American Champion Aircraft Corp.
Rochester, WI 53167

Service Letter: 429

Date: May 29, 2007

Title: Inspection of Stereo Headphone Wiring

Intercom Connector

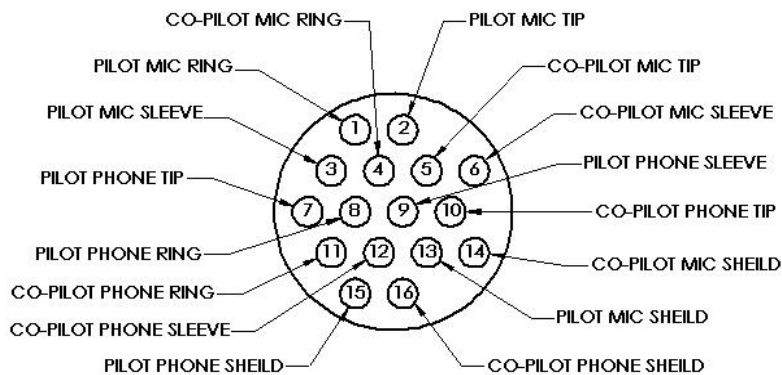
Verify correct connection of pins 7, 8, 10, and 11 to the ¼" headphone jacks using a continuity device. If necessary, swap pins 7-8 and 10-11 to match the diagram below. An AMP 305183 extractor or equivalent tool should be used to disengage the pins.
